Hurricane Planning Commission Meeting Agenda

October 13, 2022
5:00 PM

Agenda Date:	10/13/2022
Application Number:	2022-ZC-29 2022-PSP-25
Type of Application:	Zone Change and Preliminary Site Plan Application
Action Type:	Legislative
Applicant:	Hinton Holdings LLC
Agent:	Richard & Kathleen Hinton
Request:	A Zone Change from R1-10 and Highway Commercial to R1-8 PDO and Highway Commercial
Location:	Approximately 88 N 1690 W
Zoning:	R1-10 and Highway Commercial
General Plan Map:	Single Family

ZONE CHANGE MAP
699-001 CARLON ACRES
LOCATED IN SECTION 33, T41S, R13W, S.L.B.&M. WASHINGTON COUNTY, UTAH

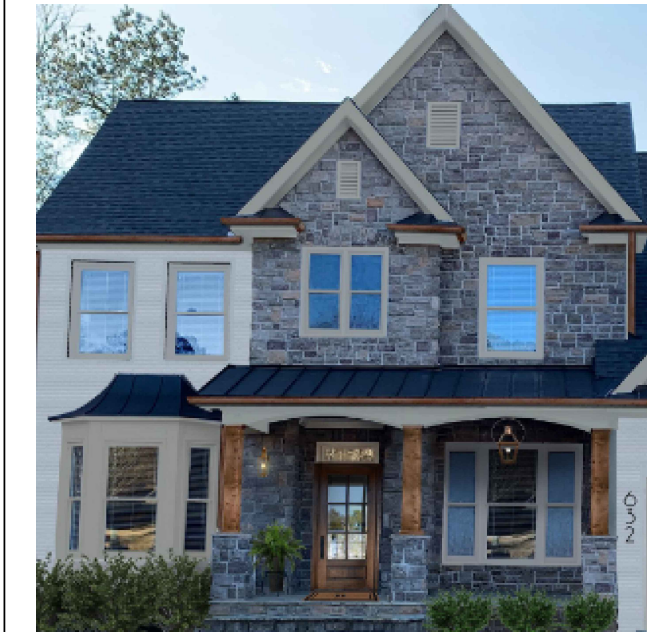
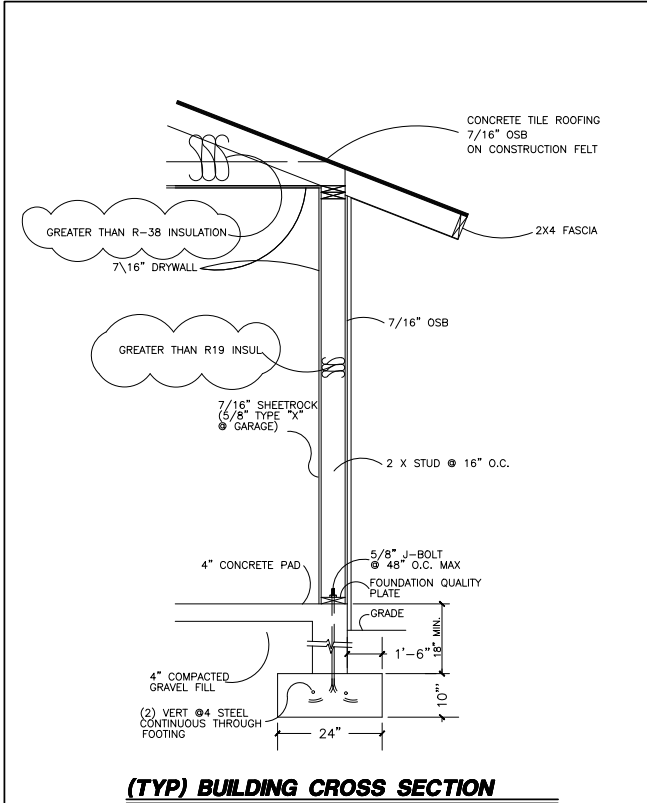
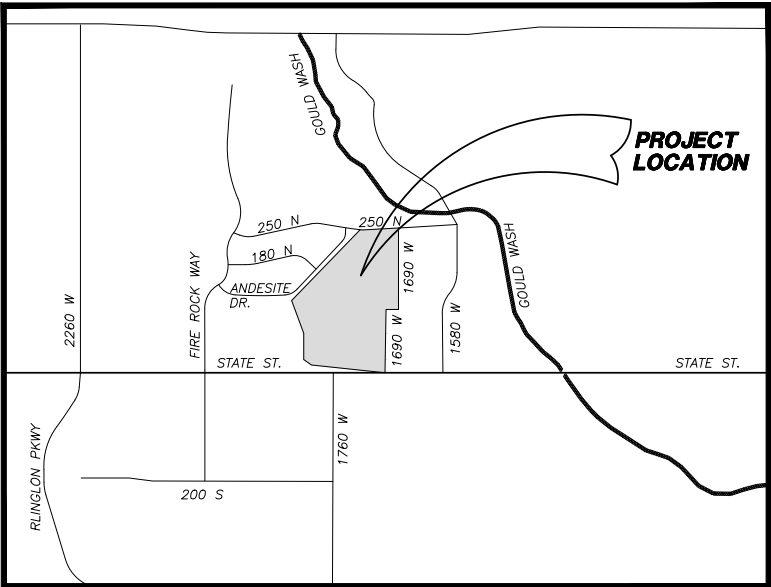
Update 10/13/2022: The applicant has provided a density bonus calculation breakdown. The applicant is proposing density bonus features equaling about 22.09 to 24.59 points, per code the Planning Commission can only grant a 20% density bonus. Staff has no concerns with any of the proposed justifications for the density bonus.

1. **Sewer:** No comments.
2. **Water:** No comments.
3. **Fire:** Okay with zone change. No parking signs required on turnaround in HC area.
4. **Engineering:** Interconnectivity is encouraged, however the extension of 180 N may not be feasible with the required grading. Check for double frontage lots. Check drainage plan. Lot 53 is in Zone AE floodplain. Coordination with neighbors required for development of 1690 W. The Transportation Master Plan doesn't show 100 N in this area however that might be desirable. Specific approval from the City Engineer is required for a street to end without a cul-de-sac

5. **Streets:** Okay with zone change. Are the streets in the R1-8 zone private or public?
6. **Power:** Existing power line on the south side will need to be put underground. A fee of \$900 will be charged to the owner/developer to design the power system. This must be done before construction drawings. Load calculations for pool/rec area and commercial lots must be given before design. Easements need to be obtained and turned over to the city.
7. **GIS:** Street names required on some internal streets.

1. **Density:** The Preliminary Site Plan shows 52 units on 10.065 acres. This is a density of 5.16 units per acre. The max R1-8 PDO density is 4.4 units per acre. The applicant could ask for a density bonus; however at this time no density bonus has been requested.

2. The property owner to the west has come to city staff about an easement located on the south end of this property that would not allow it to be developed in the manner shown on the site plan. Staff is still investigating these claims at this time.

PRE PLAT PLAN: BASH RESORTS

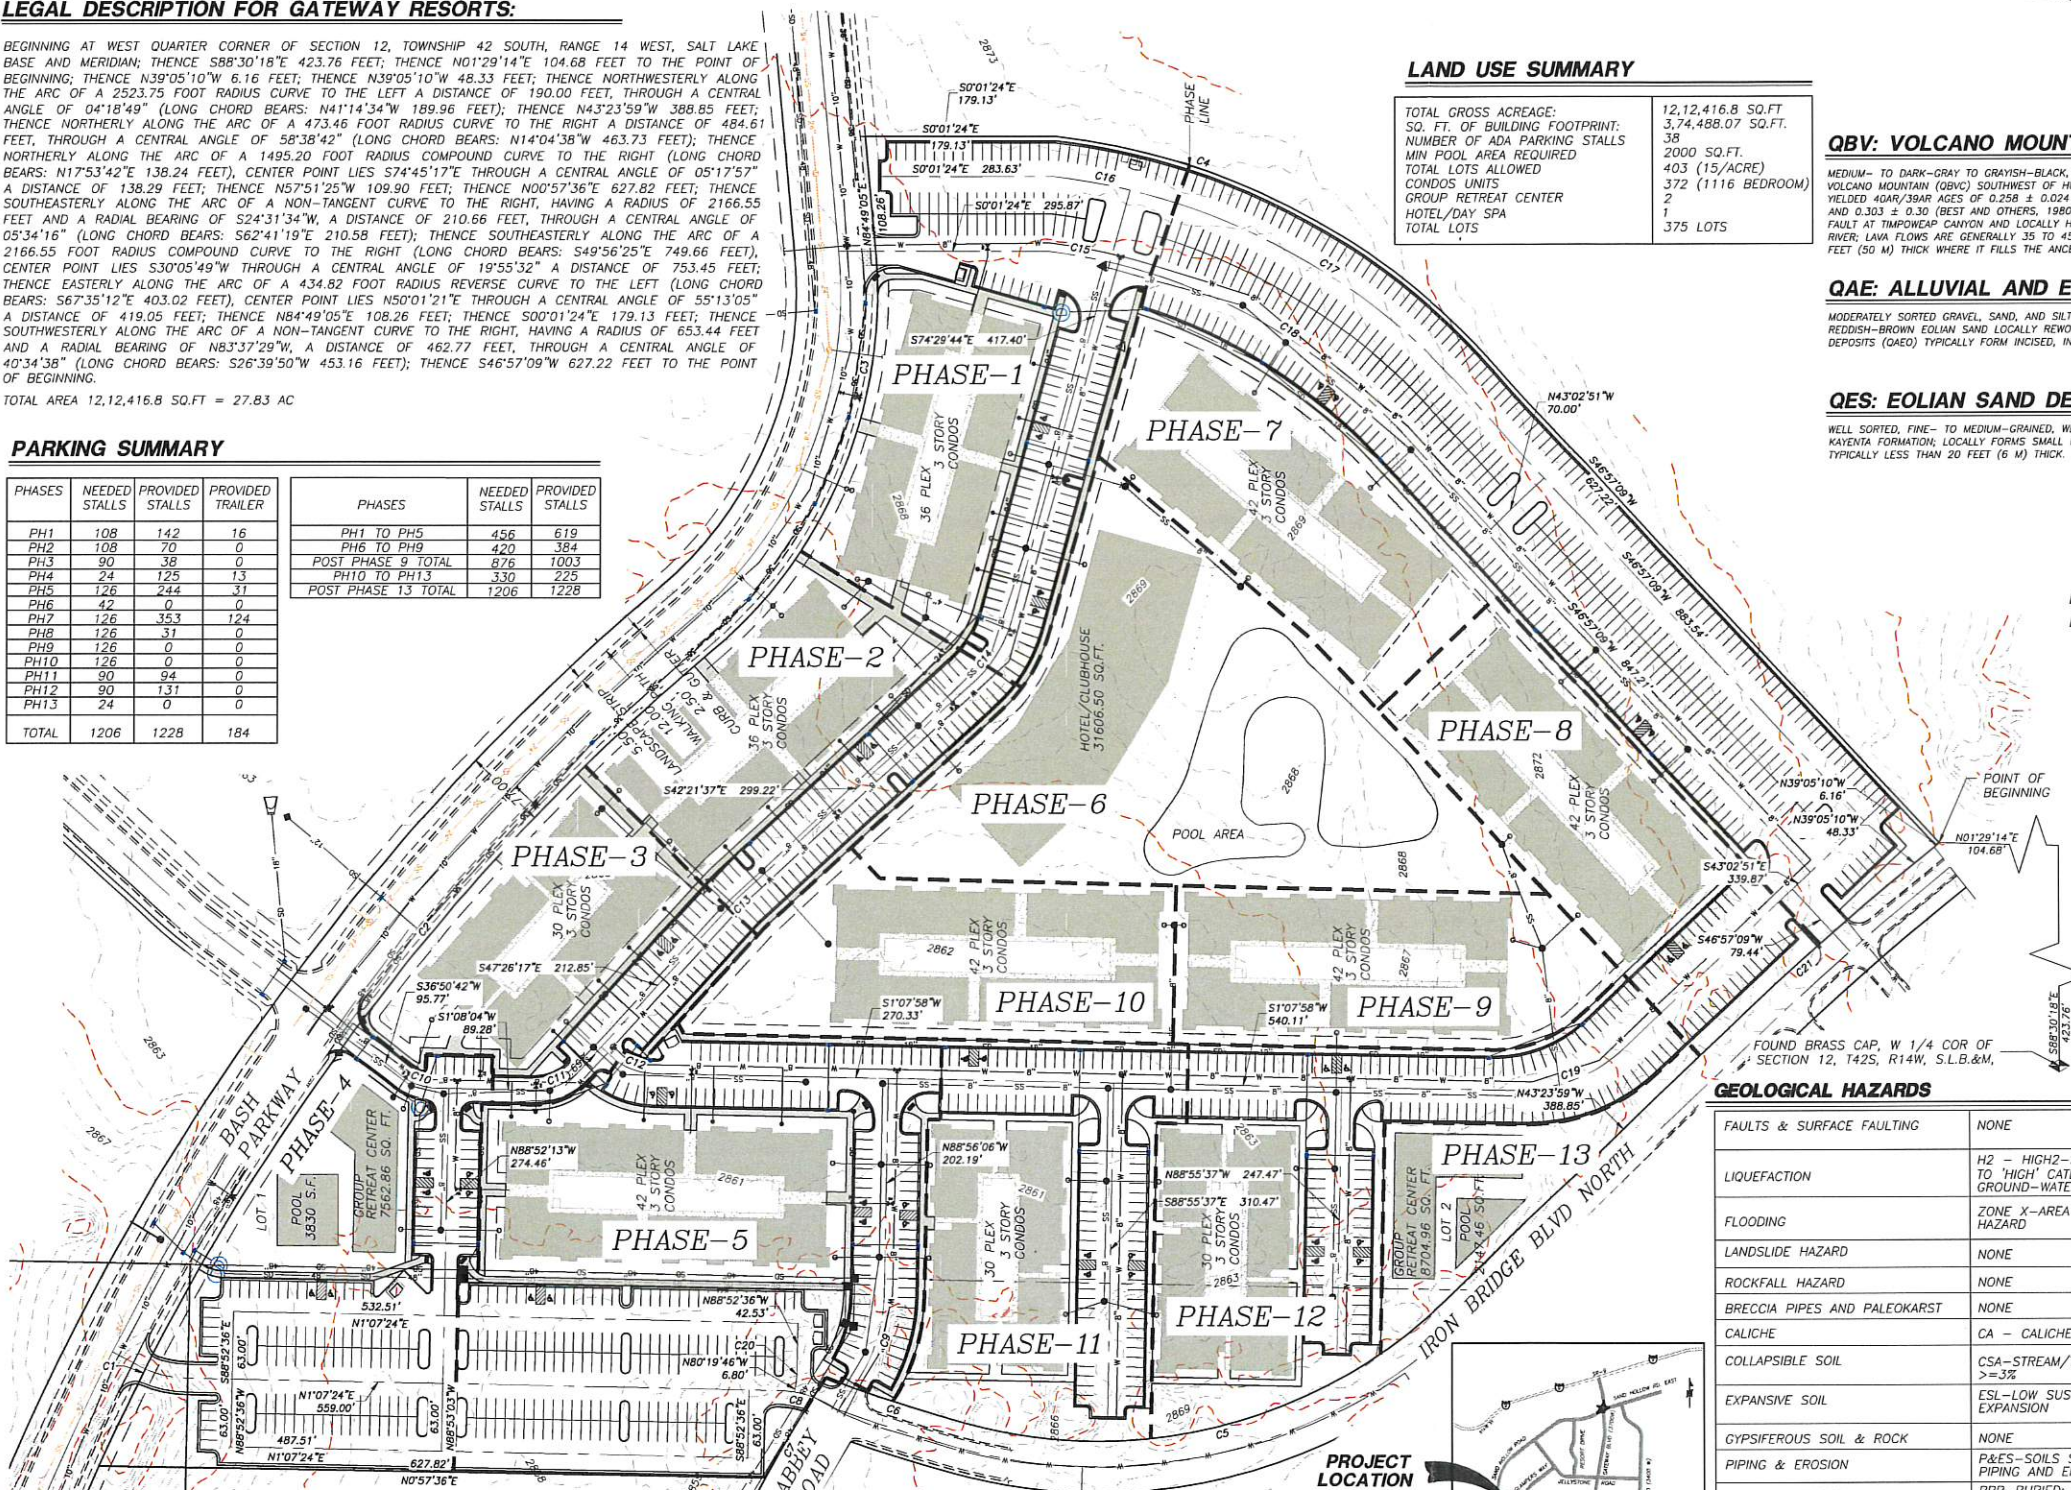
2. All streets within the development are planned to be private.
3. **Parking:** Per HCC 10-26-6: *“Within recreational resorts, an application shall provide two parking spaces per unit or one space per bedroom, whichever is higher. Tandem parking spaces are permitted only if approved as part of the preliminary site plan by the Planning Commission.”*

- a. The site plan indicates that 1206 parking spaces are required and 1228 spaces are provided
 - b. RV/trailer spaces are also required at a rate of one space per five units. 75 spaces are required and approximately 184 are provided

- c. Phase 6 is shown as being a hotel and clubhouse area. Per HCC Table 10-34-1, hotels require, *“2 spaces plus 1 space per living or sleeping unit”* It is not entirely clear that this requirement was accounted for in their parking plan since they show 42 required spaces for 31,606 sq ft hotel.

- d. It appears the parking lot on the northwest corner stretches into the Neighborhood Commercial zone. Staff has decided to count this as off-site parking because of the different zone and Planning Commission will need to approve it. The standards are as follows:

4. **Amenities:** Per HCC 10-26-4: two clubhouses of at least 2,000 sq ft of nonoffice space and 4 pool areas of at least 2,000 sq ft are required. Upon speaking with the applicant they would like to propose a larger pool amenity in the center of the development as an exception to the four pool areas requirement. HCC 10-26-4 states: *"Pools: Pools may be combined for an enhanced amenity area with the approval of the Planning Commission."* Staff believes this is a good place for this exception.

b. Bash Parkway is a master planned roadway so block lengths can be longer on that road. Staff would recommend pedestrian connectivity to Bash Parkway.

f. Staff finds this parking plan to be acceptable.

SITE PLAN FOR:
MARLA PHASE 2

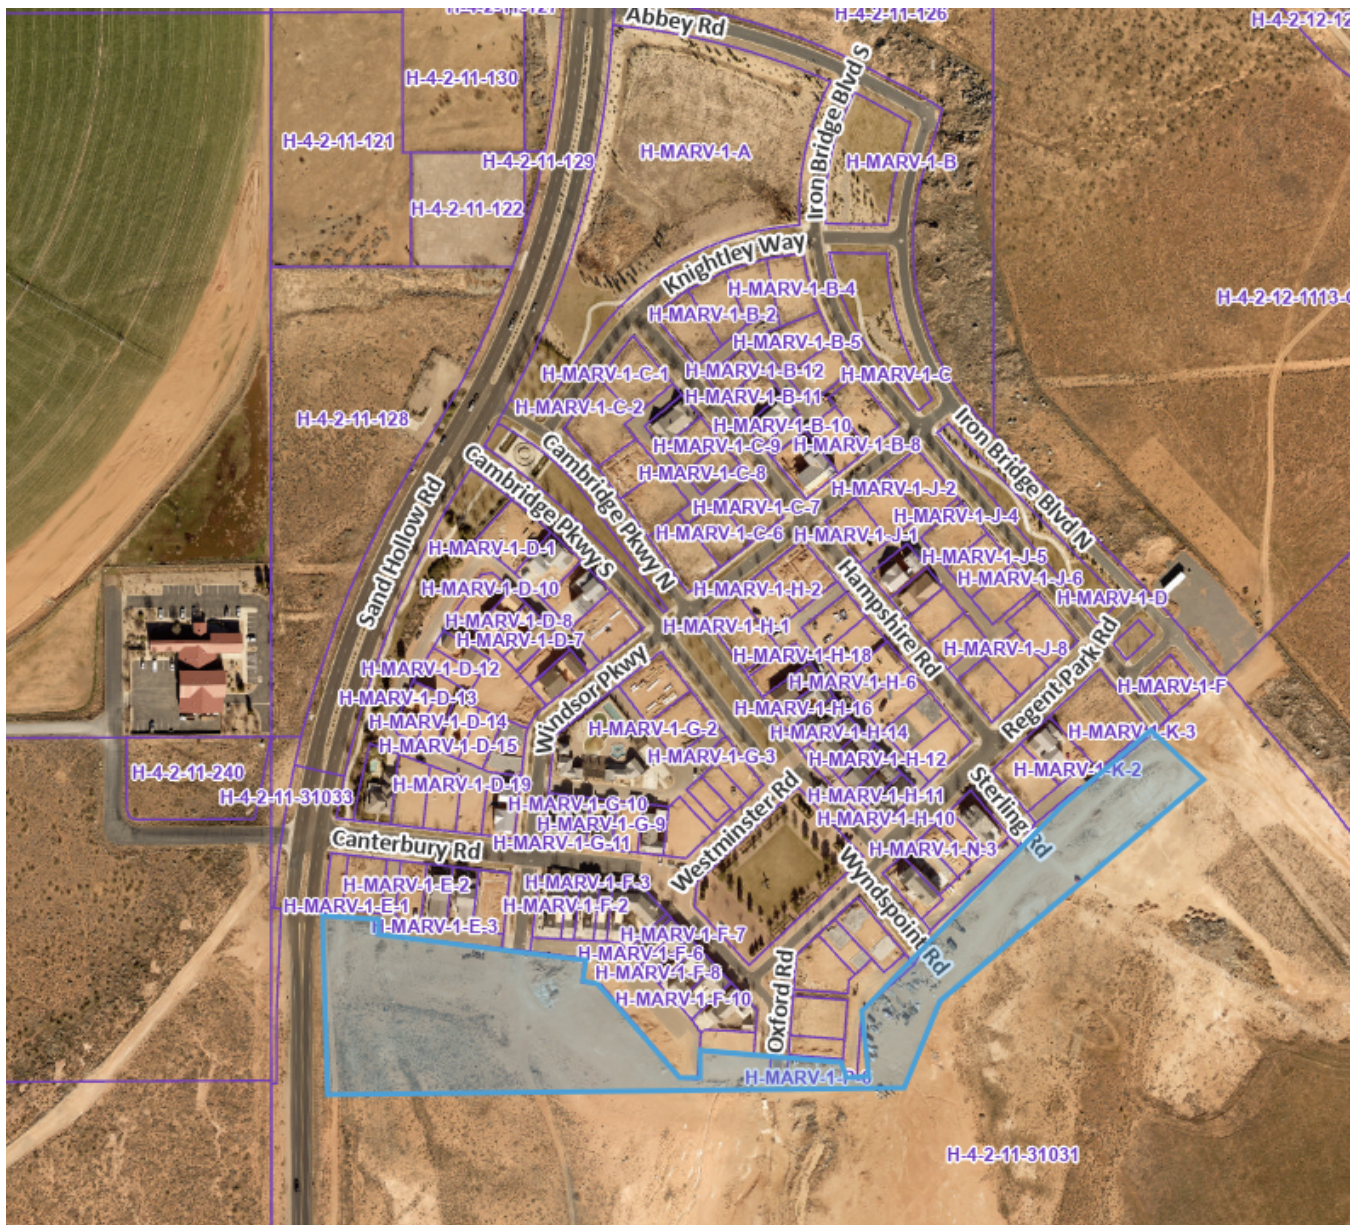
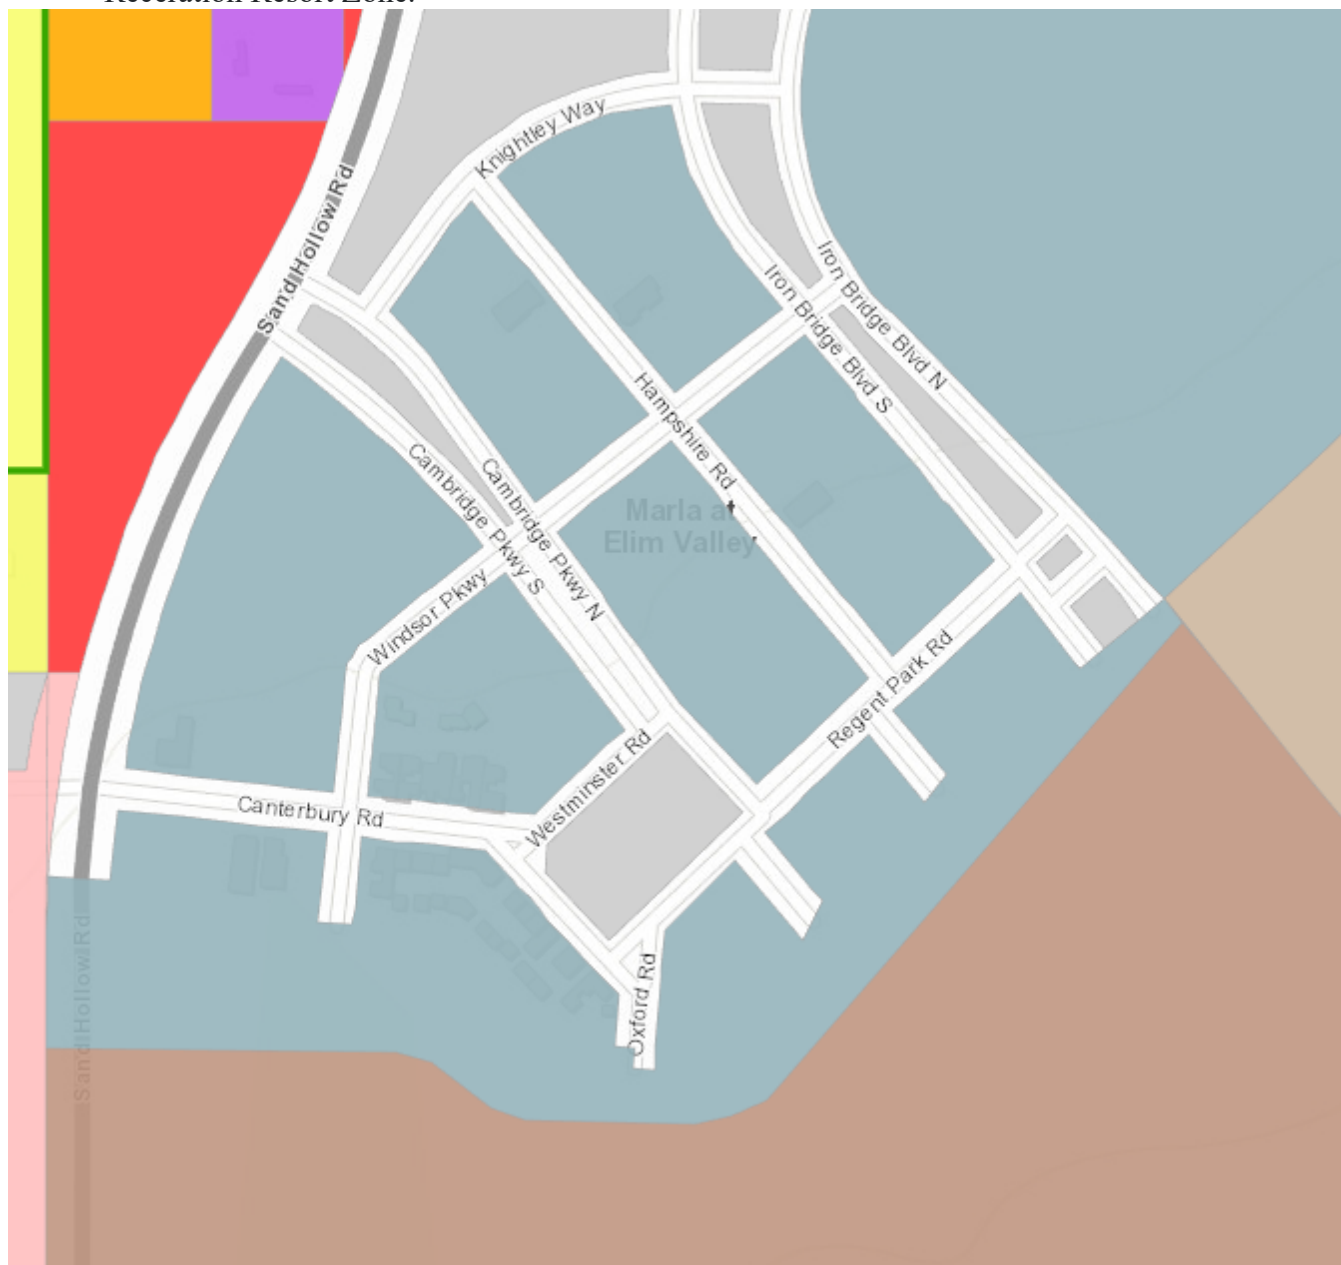
Parks: Are roads accessing detention/park area public or private? If private then the parks department is against this being a city park. Park will need to be built to city park standards including size/acreage. Park design, installation, and construction will need to be coordinated with the parks department.

Streets: What areas will drain to the detention basin? How will these plans affect the existing storm drain south of Marla?

Engineering: Engineer needs to submit information sufficient to indicate vertical and horizontal alignments are maintained. Check survey details. The southern boundary for Ironbridge Blvd south is discontinued here. Hurricane design standard 3.2.4.4.5 (A) specifies that no road shall be ended without a properly designed cul-de-sac turnaround. Why aren't the streets being extended to the next property owner over? Streets over 150' require a temporary turnaround. No indication of a smooth change from 64' ROW to 52' ROW on the southern end. Most of Sand Hollow Road is on parcel H-4-2-11-31031. It

seems the right of way for Sand Hollow Road hasn't been dedicated yet. Will typical PUE be dedicated on the extension of Windsor Parkway, Oxford Road, and Ironbridge Blvd south
